8/16/24 – MISSING WATER RESOURCES DEPARTMENT COMMENTS

RE: **2-ZN-2024**

Artessa
G0949 (Key Code)

PRELIMINARY DRAINAGE REPORT

OVERALL SITE
PLAN

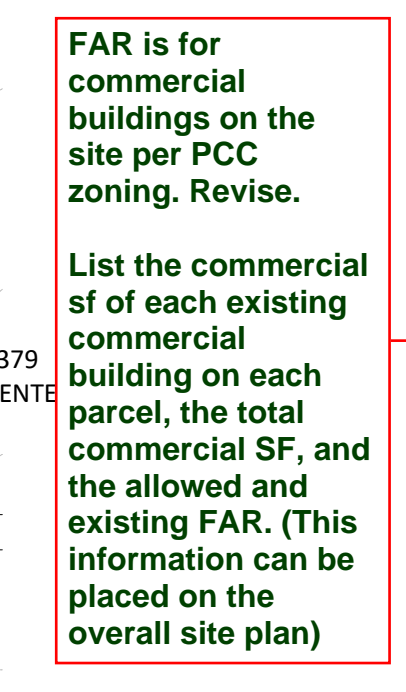
NOTE: APPLICANT IS UTILIZING 2024 PCC DEVELOPMENT STANDARDS.
LIST THE ALLOWED AND PROPOSED DENSITY ON THIS SHEET.
LIST THE ALLOWED AND PROPOSED COMMERCIAL FAR ON THIS SHEET. (0.25)
FAR is for commercial buildings on the site per PCC zoning.
List the commercial sf of each existing commercial building on each parcel, the total commercial SF, and the allowed and existing FAR.

ARTESSA PINNACLE PEAK
PROPOSED CONDITIONS DRAINAGE AREA MAP

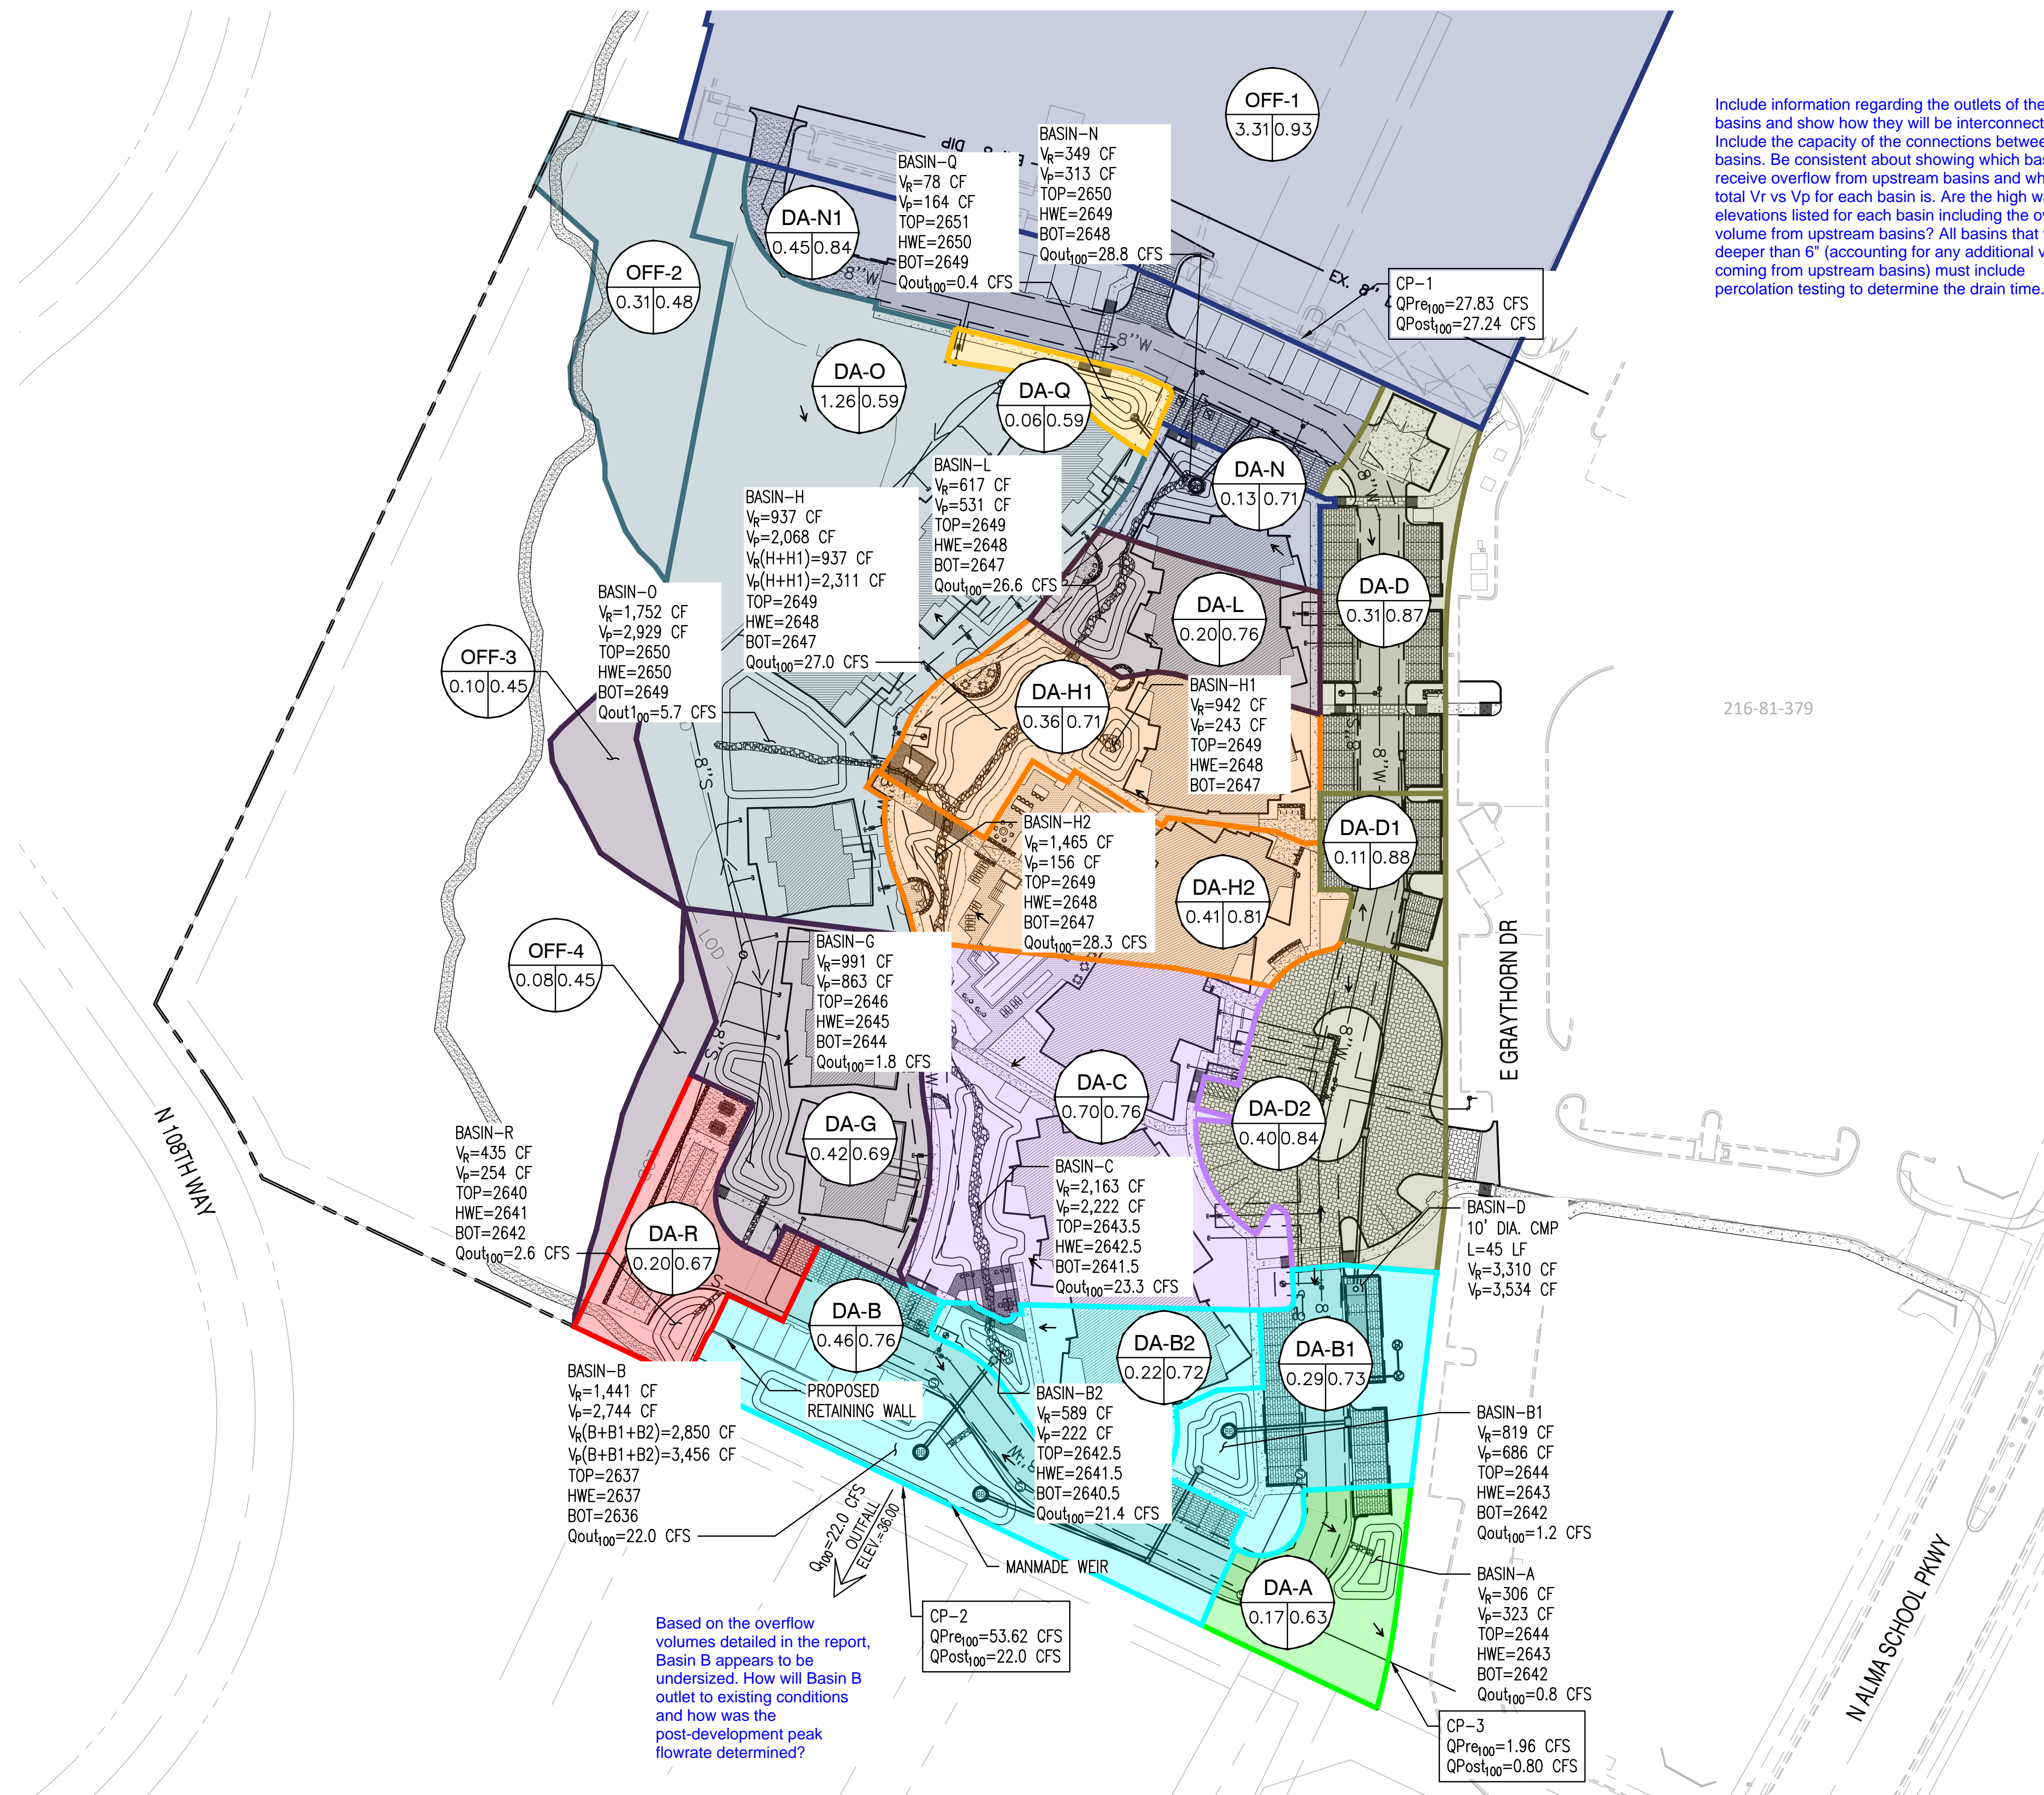
Include information regarding the outlets of these basins and show how they will be interconnected. Include the capacity of the connections between basins. Be consistent about showing which basins will receive overflow from upstream basins and what the total Vr vs Vp for each basin is. Are the high water elevations listed for each basin including the overflow volume from upstream basins? All basins that will be deeper than 6" (accounting for any additional volume coming from upstream basins) must include percolation testing to determine the drain time.

PRELIMINARY
GRADING AND
DRAINAGE PLAN

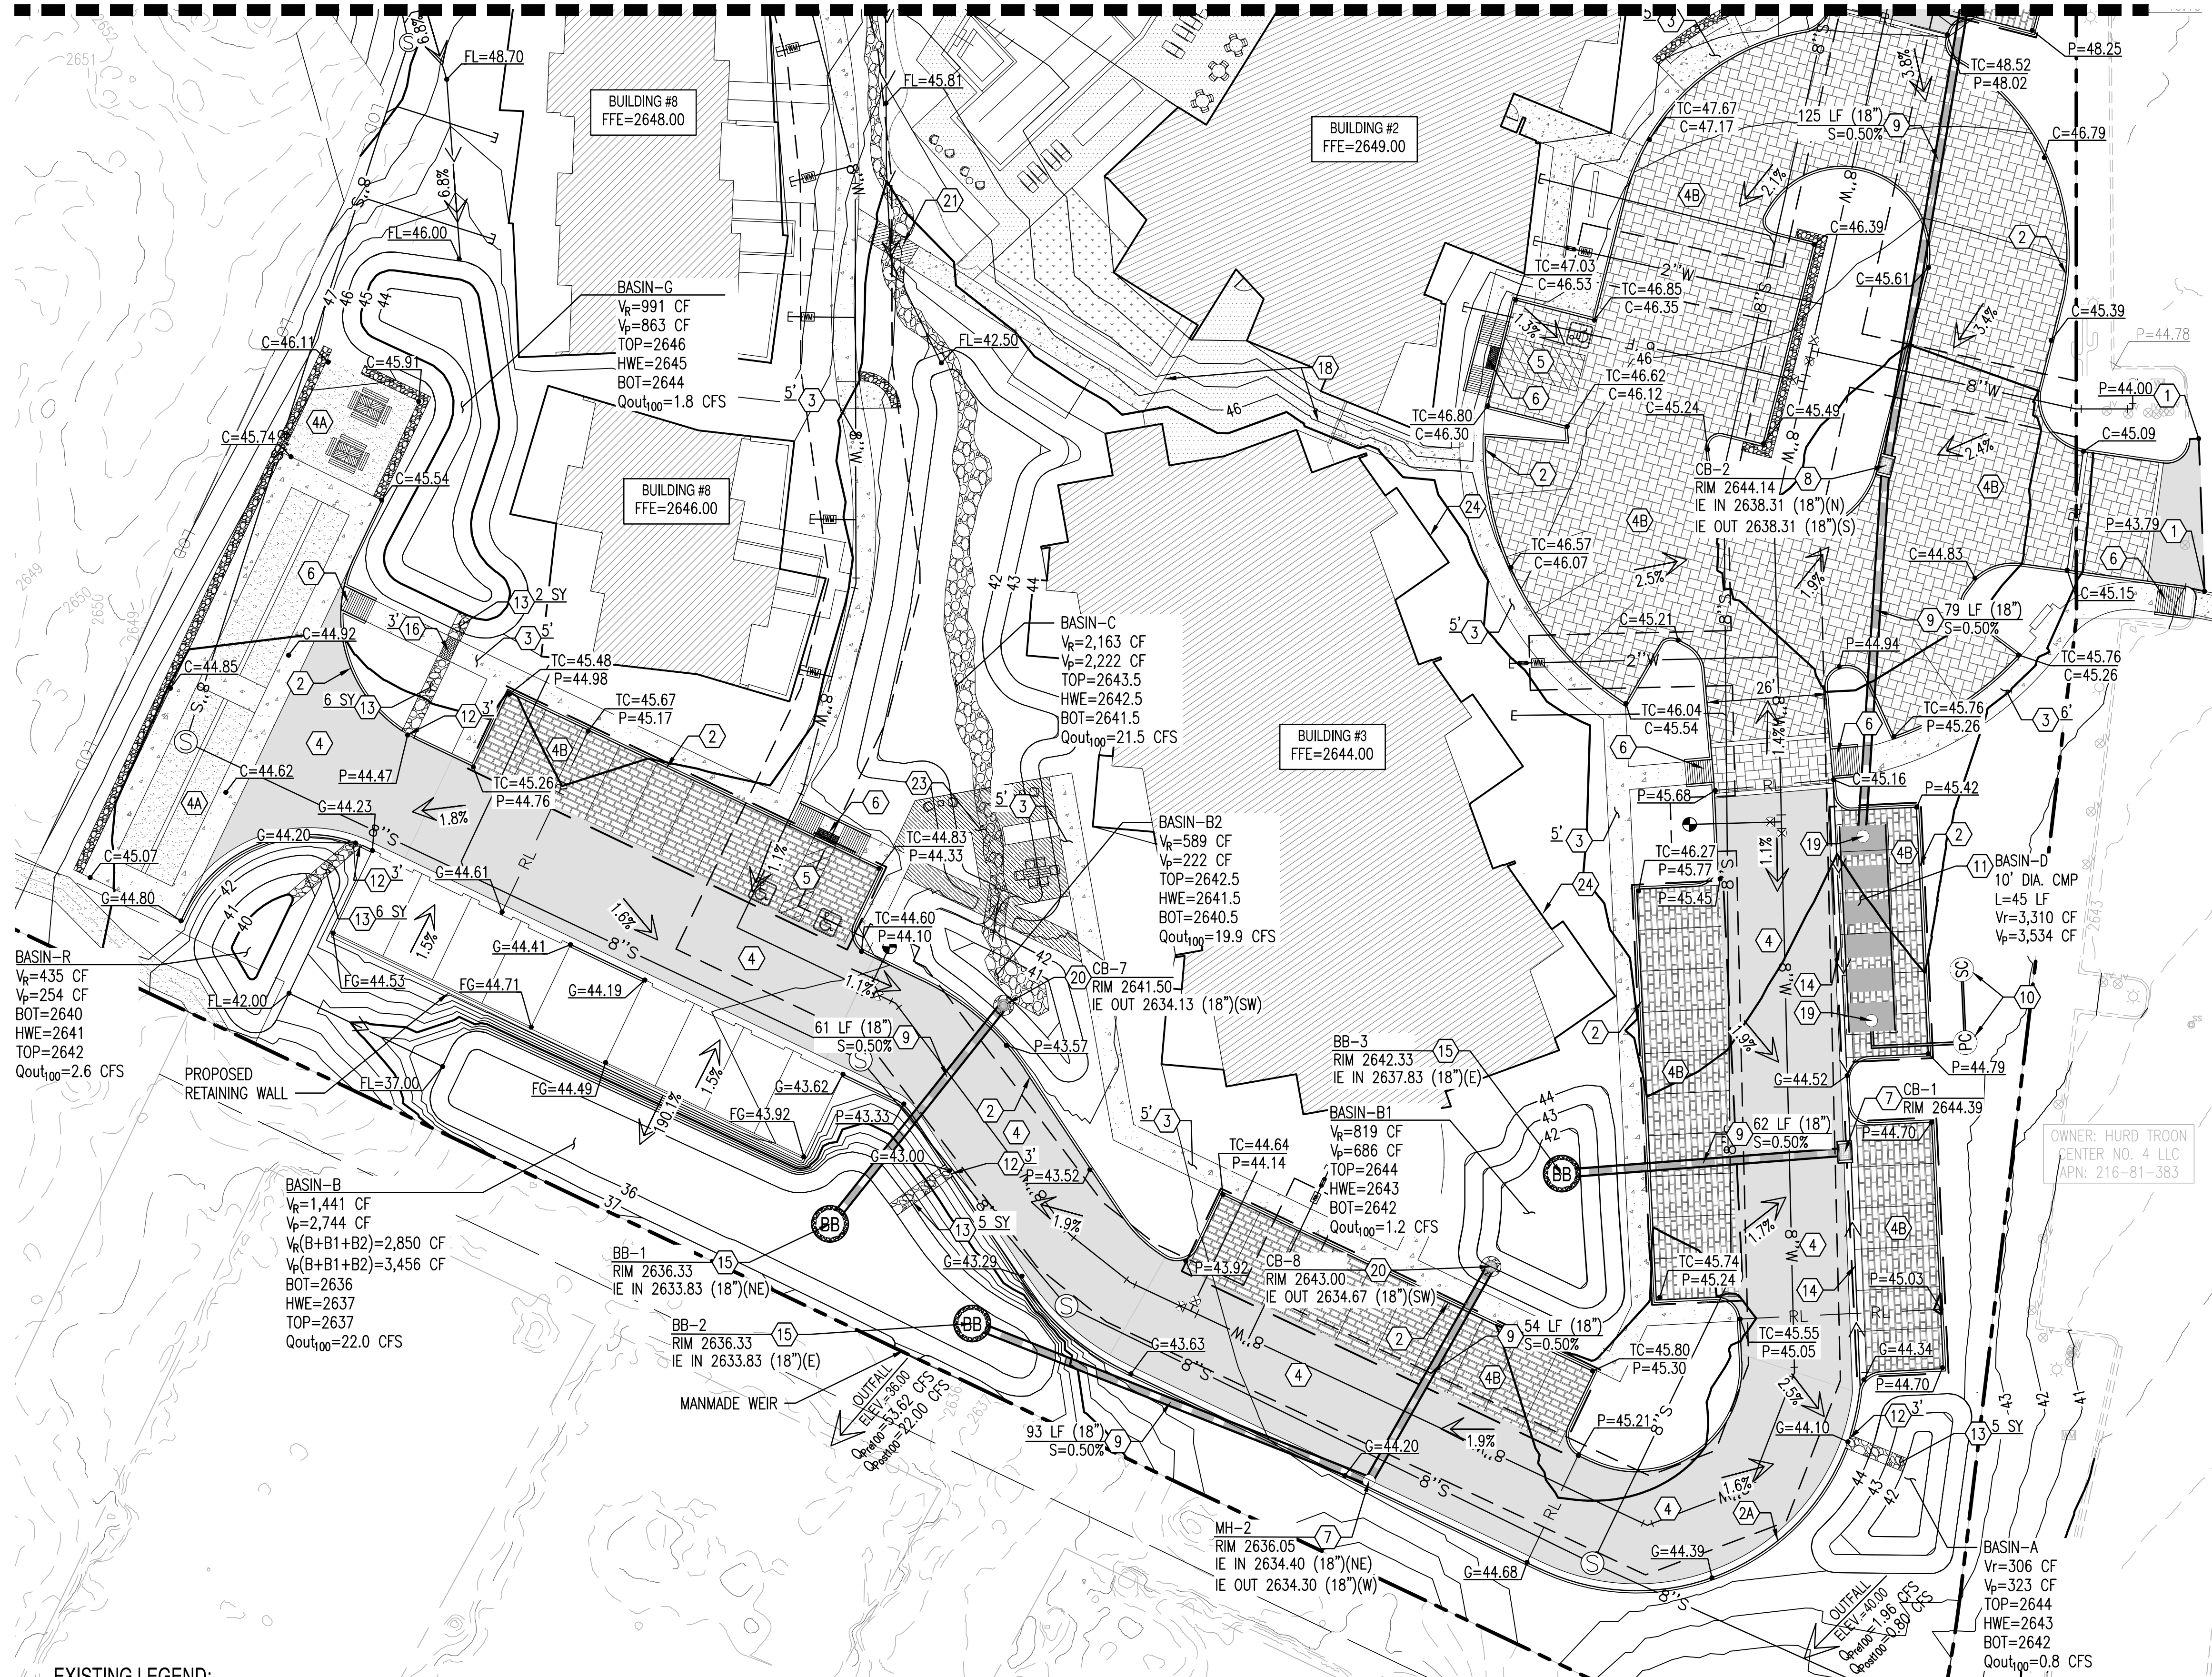
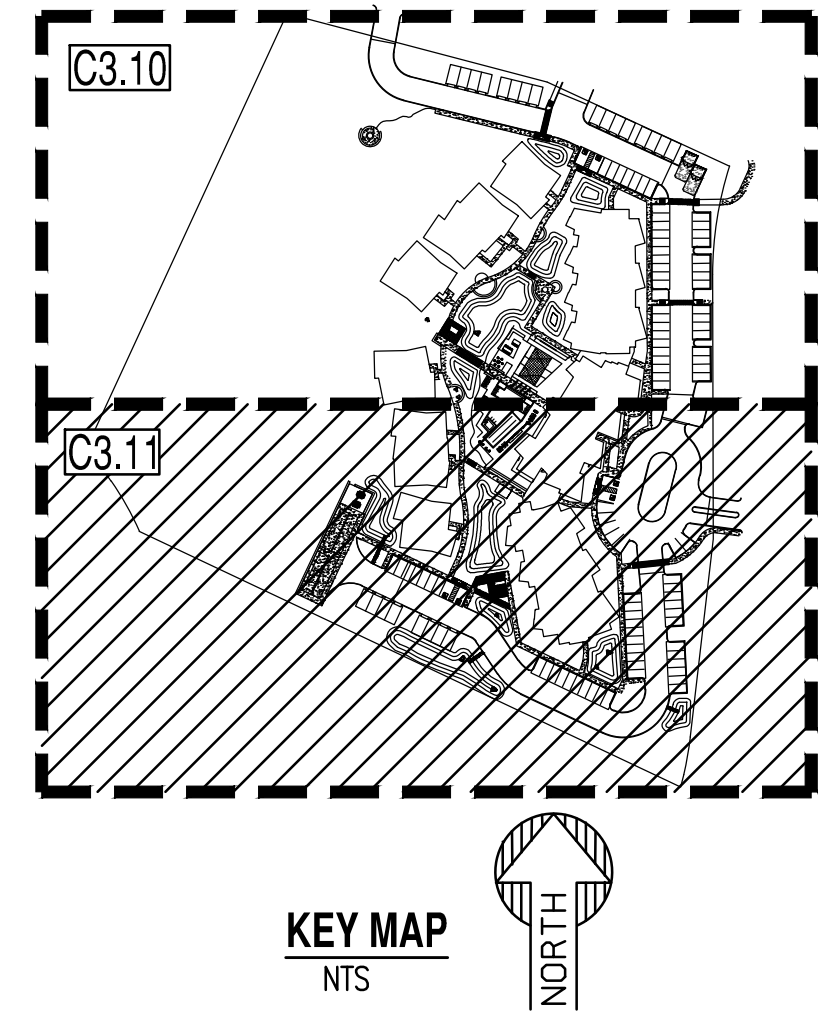
Include information on the infrastructure connecting all of the basin (sizing, material, etc) as well as any drywells required for the basins that will be over 6' deep.
